Staff Report

REPORT NO.: DSD-2023-162

SUBJECT: Minor Variance Application A2023-047 – 744 King Street East

Figure 5: 45 Degree Angular Plan Analysis (from Residential Zone)

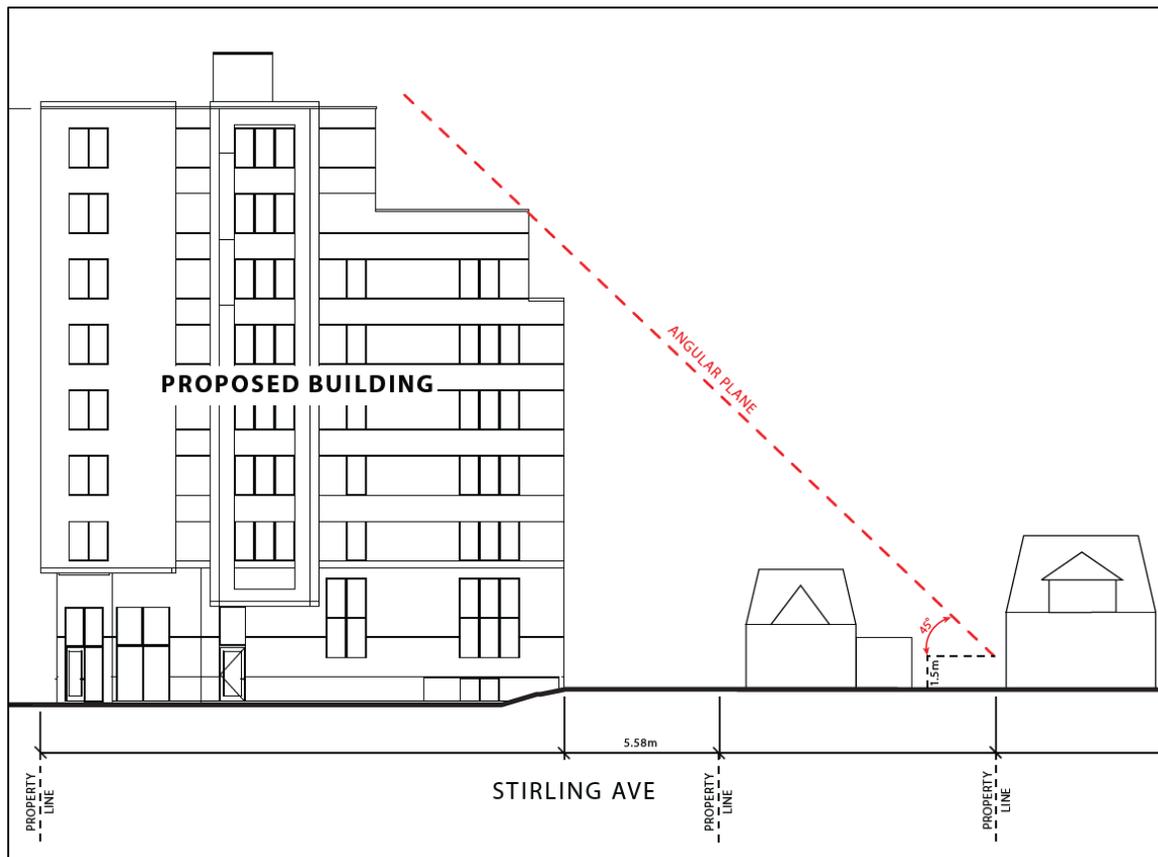
The zoning by-law establishes a transition in height using two metrics: maximum overall height and an angular plane which steps down to neighbouring lands having a residential zone. Staff note that while lands immediately adjacent to the subject site contain a low-rise dwelling, the lands are also zoned 'MU-2' (see Figure 1) and are excluded from the step-backs to the residential zone. The zoning by-law permits a maximum height of 12.5 metres within 16 metres of a residential zone and permits an additional metre in height for every additional 0.6 metres in setback (as illustrated in Figure 4). This angular plane is respected by the proposed built form, including the 7th and 8th storeys which exceed 19.5 metres in height. The building has also been designed to respect a 45 degree angular plane from the first house in the residential zone. The 45 degree angular plane is a useful metric to evaluate a transition in heights in order to protect access to light (minimize shadow impacts) and minimize overlook as higher storeys are setback further. As is shown in Figure 5 the proposed built form respects a 45 degree angular plane. A Shadow Study completed for the subject proposal (see Attachment 1) demonstrates that shadow impacts to surrounding residentially zoned lands are limited during the spring, summer and fall, and mainly affect other Mixed Use lands.
